1. **Title:** Cyber Security — Critical Cyber Asset Identification
2. **Number:** CIP-002-3(X)
3. **Purpose:** NERC Standards CIP-002-3(X) through CIP-009-3(X) provide a cyber security framework for the identification and protection of Critical Cyber Assets to support reliable operation of the Bulk Electric System.

PRC-006-1(X) – Attachment 1

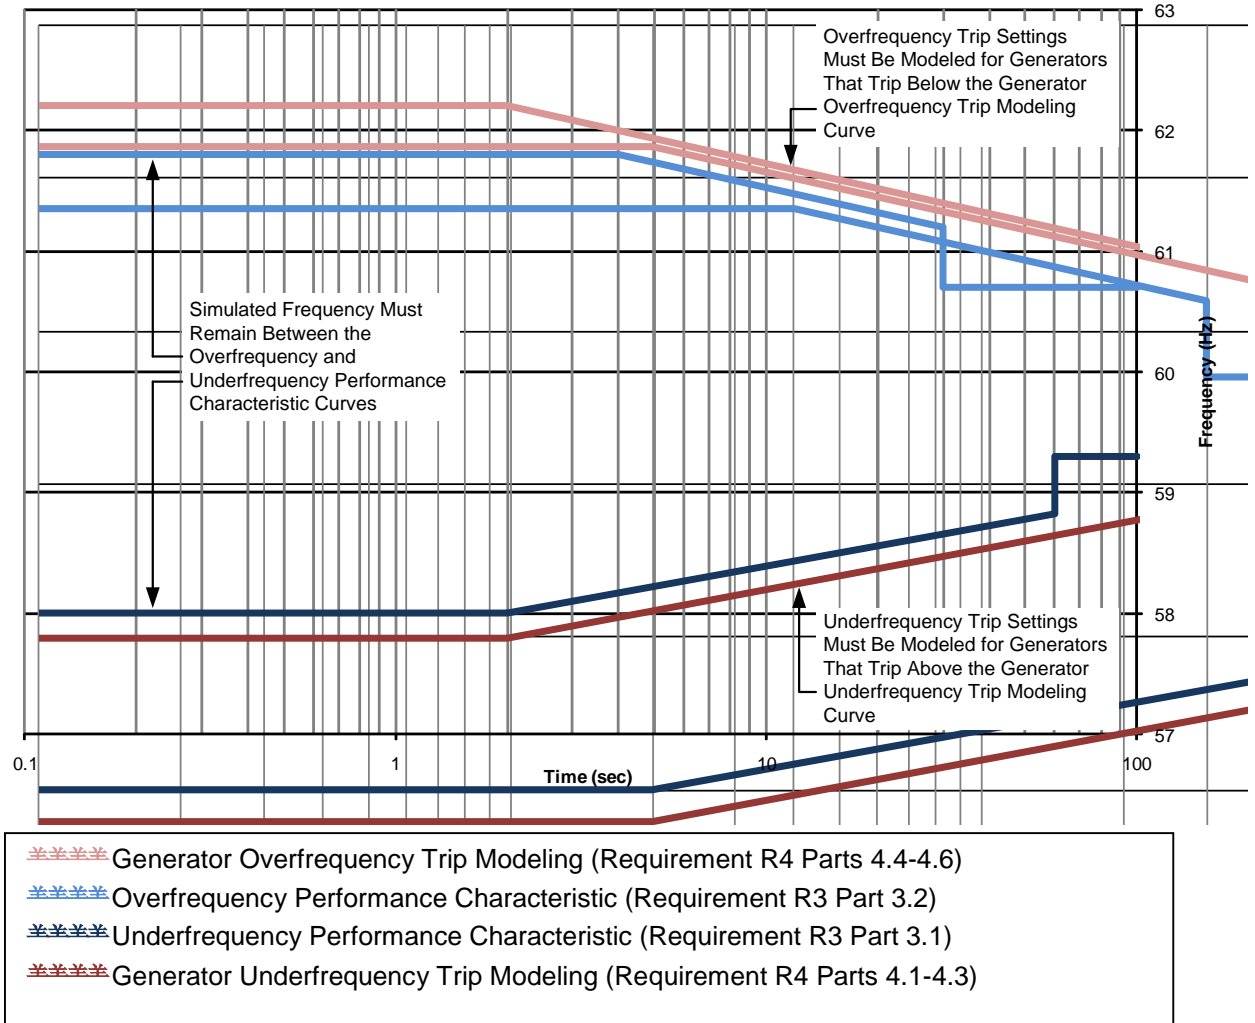
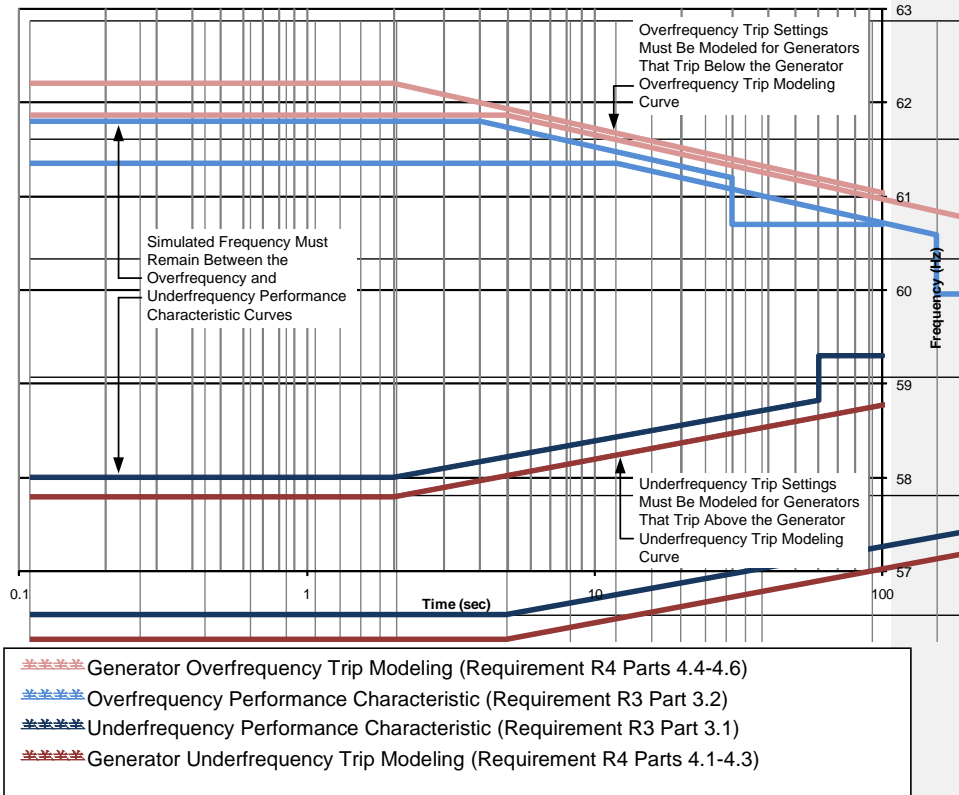
| Version | Date | Action | Change Tracking |
|----------------|------------------|--|--|
| 1(X) | TBD | Adopted by the NERC Board of Trustees | Replaced references to Special Protection System and SPS with Remedial Action Scheme and RAS |

| Version | Date | Action | Change Tracking |
|----------------------|---------------------|--|--|
| 1(X) | TBD | Adopted by the NERC Board of Trustees | Replaced references to Special Protection System and SPS with Remedial Action Scheme and RAS |
